IN THE UNITED STATES PATENT AND TRADEMARK OFFICE

In re Application of:)
Dorian Thurston TRUE, et al.)
)
Serial No. 10/766,671) Examiner: Hawk
)
Filing Date: January 28, 2004) Art Unit: 3636
)
For: Extendable Cover For A Golf Cart) Docket No.: 42576/282562

AMENDMENT AND RESPONSE TO OFFICE ACTION

FIG. 2

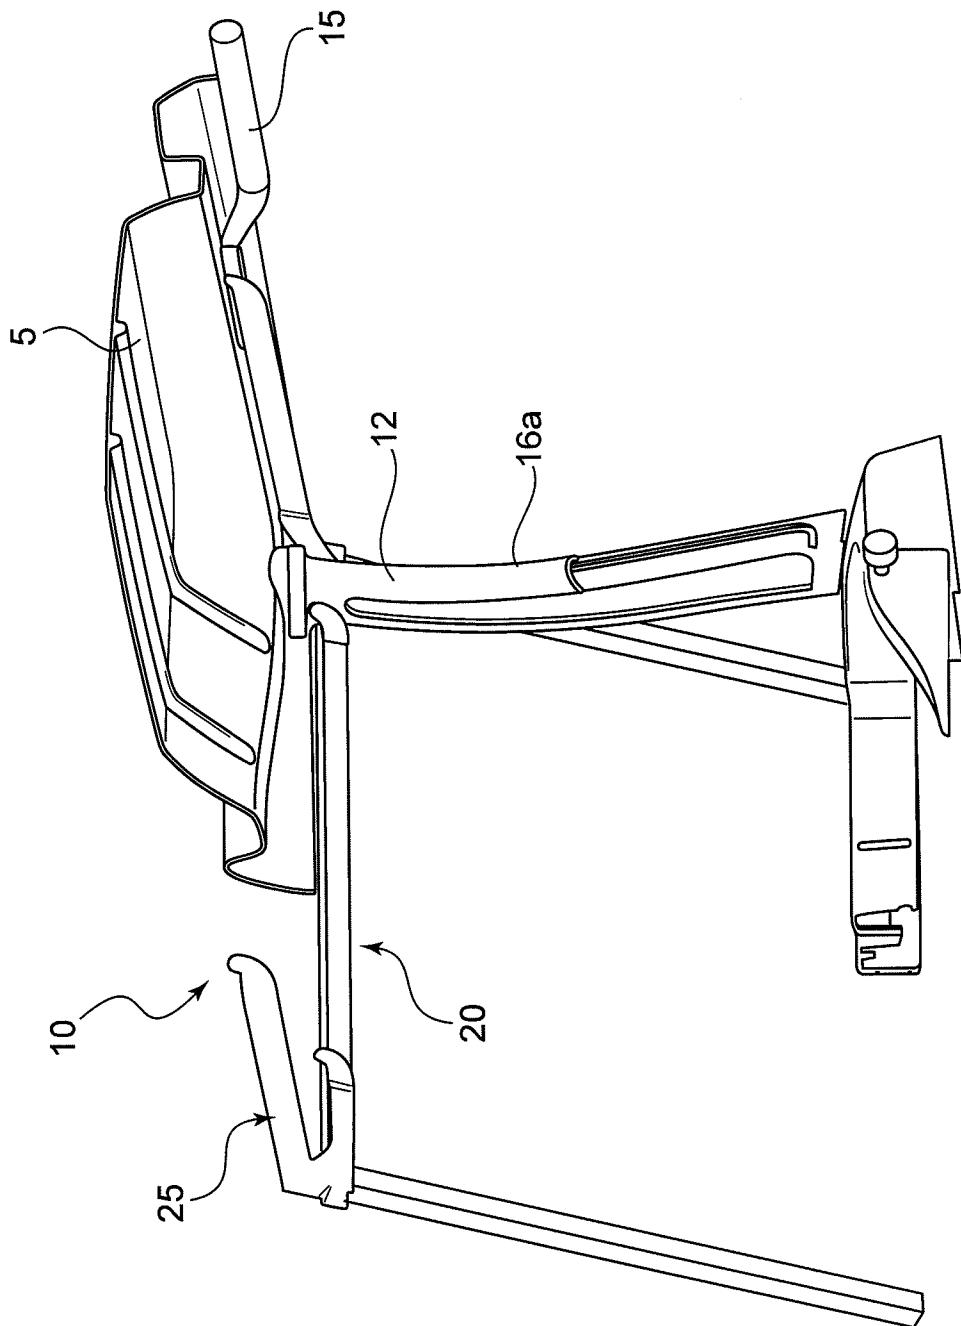
Figures 2, 5, 6 and 7 were objected to as poor depictions of the instant invention because they were black and white photographs. Corrected drawing sheets in compliance with 37 CFR 121(d) are submitted herewith for Figures 2 and 5. The Replacement Sheets

merely depict the same images as line drawings. No new matter has been added. Drawing Figures 6 and 7 are cancelled. No renumbering of figures is required and appropriate changes to the specification are detailed below in Section IV.
